# CITY OF ALBUQUERQUE

RE: **Global Storage- Coors**  
**3421 Coors Blvd NW**  
**Grading and Drainage Plan**  
**Engineer's Stamp Date 03/2018**  
**Hydrology File: G11D071**

Based on the information provided in the submittal received on 3/28/18 the above-referenced submittal cannot be approved until the following are corrected:

CG-101

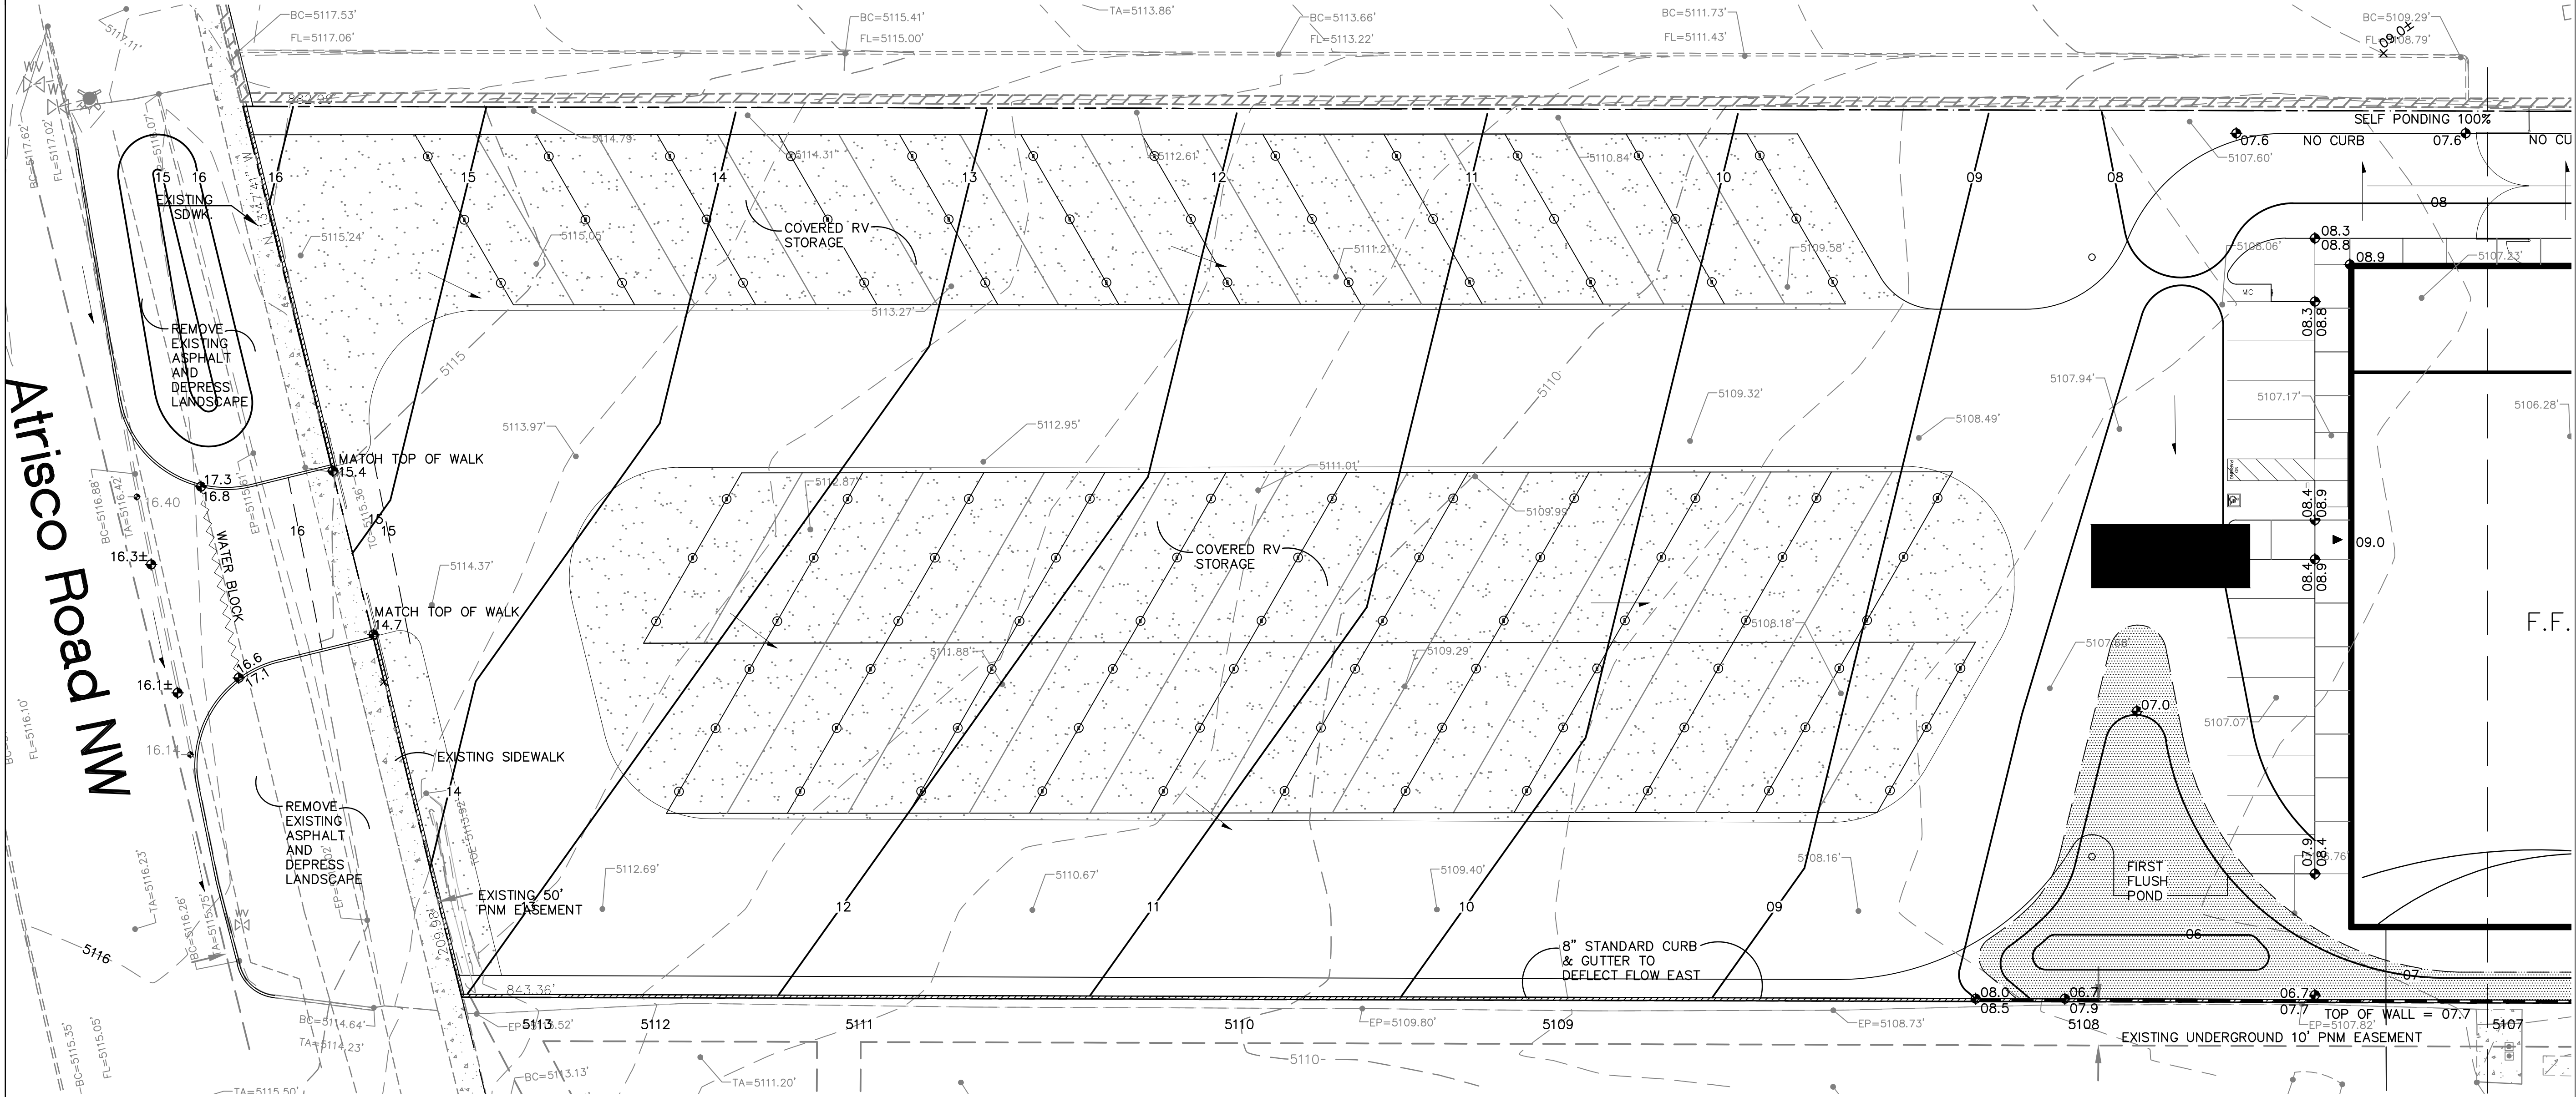
1. This site discharges to Coors Blvd, an NMDOT facility. Written concurrence must be obtained from NMDOT D3 Drainage that this project can proceed. Please contact Tim Trujillo P.E (TimothyR.Trujillo@state.nm.us).

2. Add note on the plan that "No work shall be performed in the public ROW without an approved Work Order or Excavation Permit."
3. Provide written permission from the property owners to the north and south for the work on their properties to build the new driveway entrances onto this property. If there will be cross-lot drainage occurring at these new access points, that permission should be included as well. Since an access easement will likely be required, the drainage language can likely just be added to that.

4. Provide additional spot elevations along the property line in order to assess the need for cross-lot drainage easements.
5. There appear to be a few areas where impervious areas are not being retained on-site, such as at the driveway entrances and the dumpster access. Please clarify these basins. If unable to capture and retain on-site, quantify the first flush bypass volume and state on plans. Payment of fee in-lieu will then be required at building permit.

6. Please clarify areas of impervious vs. pervious surfacing. For instance, Basin 1 seems to be nearly all asphalt and concrete but is claimed as only 75% impervious. Provide a larger basin delineation map showing impervious vs. pervious areas and include a scale.
7. Along Atrisco, provide curb openings and size the retention areas to be able to pond the portions of Atrisco that drain to them. Since this will all occur within the ROW, a work order, or excavation permit at minimum, will be needed.
8. Either a recorded SIA with financial guarantee or close-out of the public work order is required prior to final sign-off of the Site Plan.
